Revised Site & Civil Plan (3.27.25) 38229 Manzella Dr (Markups).pdf Markup Summary

NEW OFFICE / STORAGE

38229 MANZELLA DRIVE, SLIDELL, LOUISIANA

SHEET TITLE: PROPOSED DRAINAGE AND PAVING PLAN

DRAWING NUMBER: **C100**

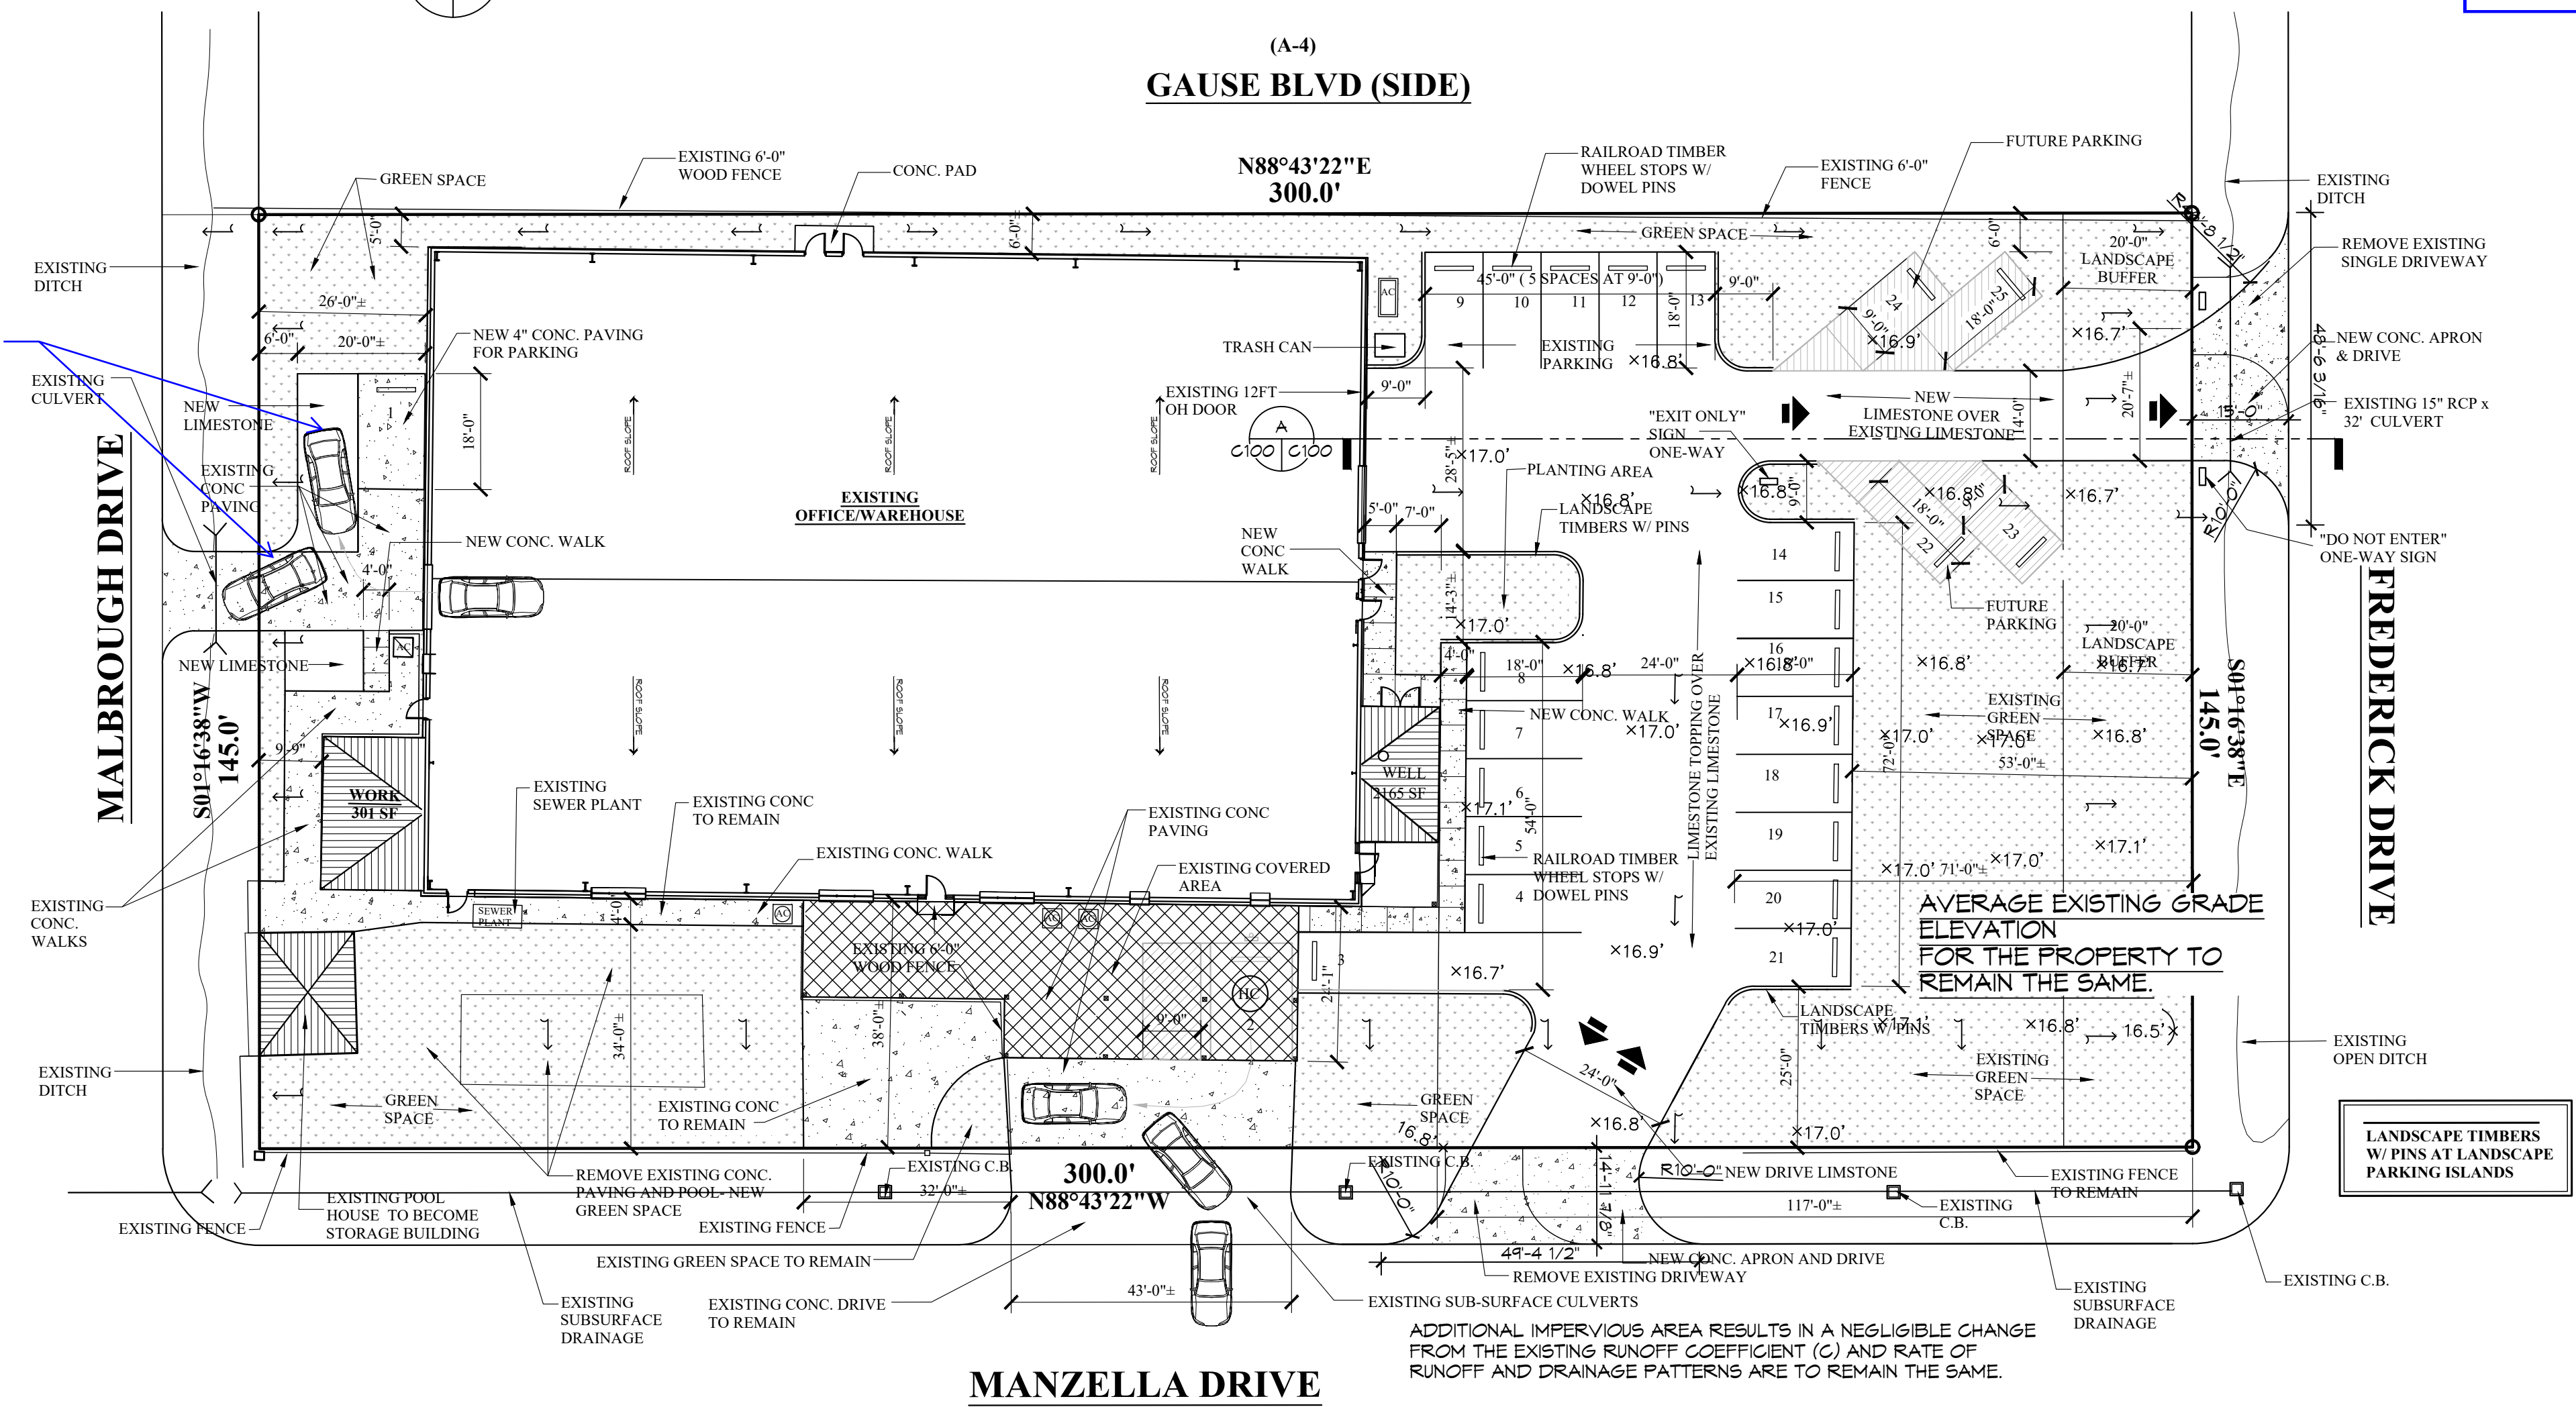
Per previous comment:

Revise Runoff Coefficient (C) = 0.95 for watertight surfaces per STP Ordinance Sec. 900-6.3(F); Exhibit 900-6-6.

Revise Runoff Coefficient (C) = 0.7 for gravel per STP Ordinance Sec. 900-6.3(F); Exhibit 900-6-6.

Revise Runoff Coefficient (C) = 0.3 for greenspace per STP Ordinance Sec. 900-6.3(F); Exhibit 900-6-6.

(TYPICAL for both pre & post development.)

Revise autoturn simulation to show proposed vehicular maneuvering to & from proposed parking space

(including wheel movement/radii). (TYP)

(Needs to show vehicle swept path.) (TYP)

Provide "Weighted" Runoff Coefficient (C) for both pre & post development.

Calculations do not appear to have been updated as required.

Per previous comment:
Revise autoturn simulation to show proposed vehicular maneuvering to & from proposed parking space
(including wheel movement/radii). (TYP)
(Needs to show vehicle swept path.) (TYP)

Per previous comment:
Provide "Weighted" Runoff Coefficient (C) for both pre & post development.
Calculations do not appear to have been updated as required.

Revised

Moved parking over to avoid conflict

Revised

SITE PLAN- NEW WORK

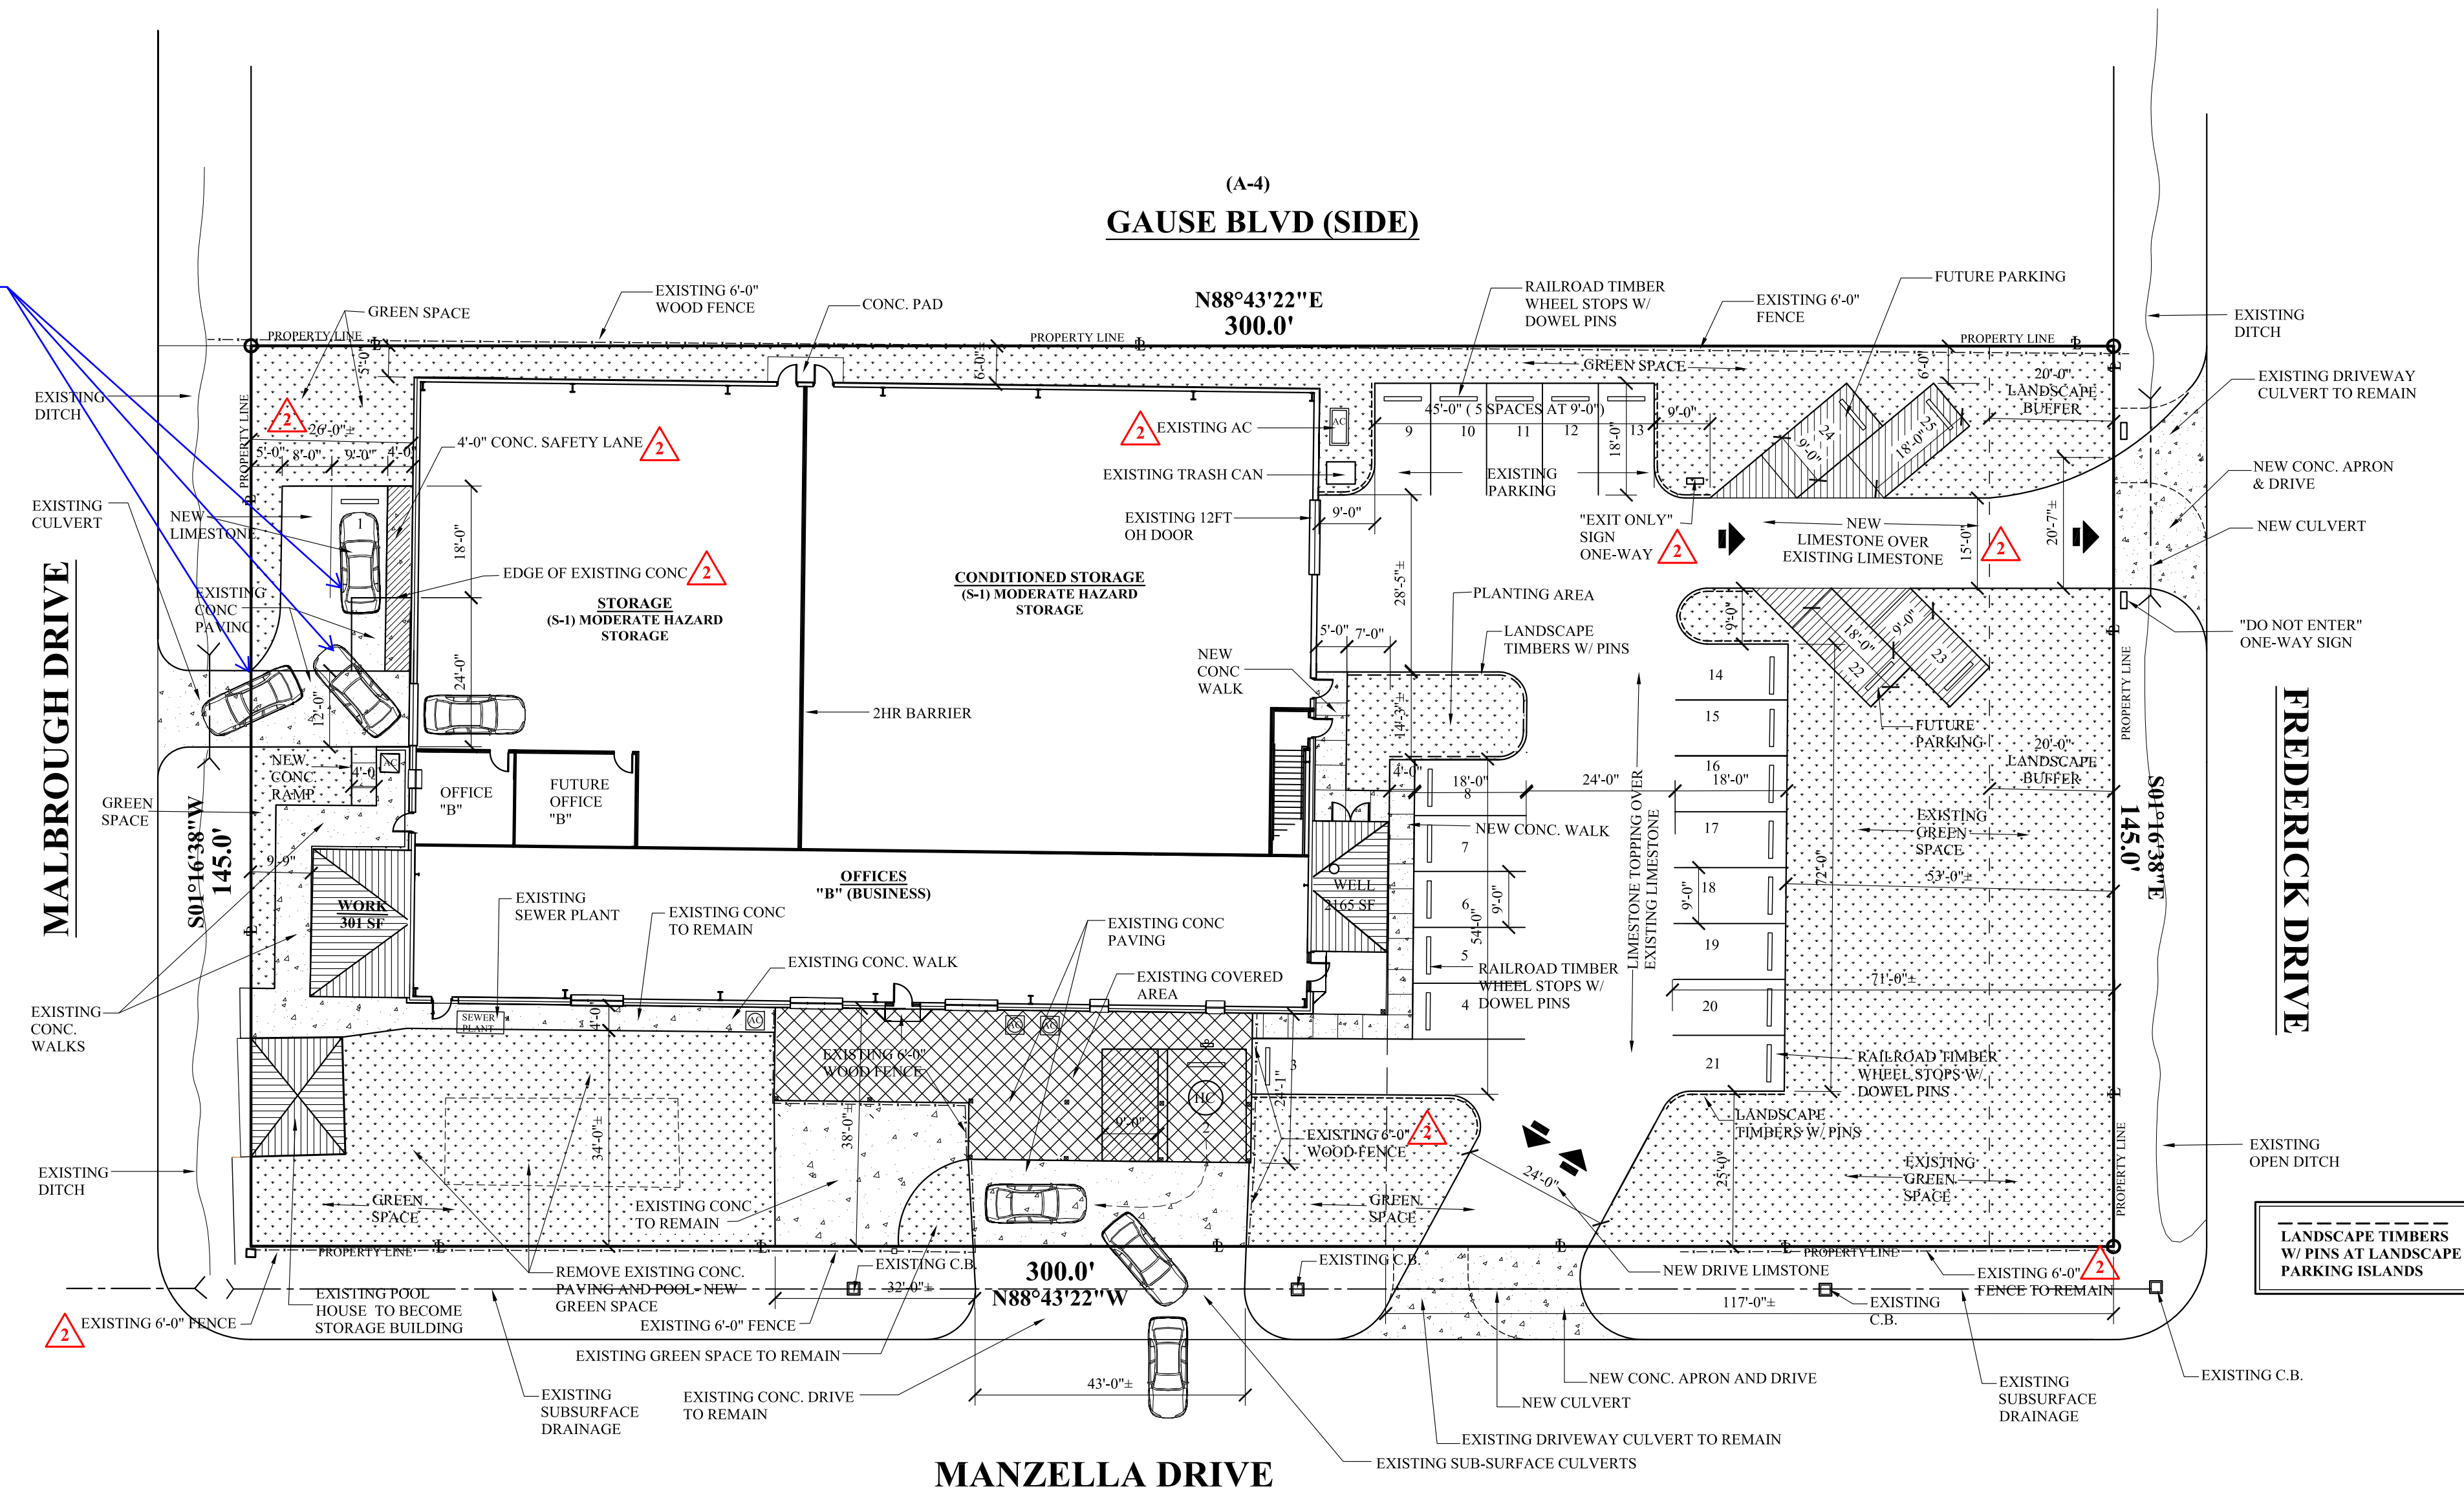
Per previous comment:

Revise autoturn simulation to show proposed vehicular maneuvering to & from proposed parking space

(Needs to show vehicle swept path.) (TYP)

This is different from what is shown on civil plan.

Revise autoturn simulation to show proposed vehicular maneuvering to & from proposed parking space

(Needs to show vehicle swept path.) (TYP)

This is different from what is shown on civil plan.

Moved parking over to avoid conflict
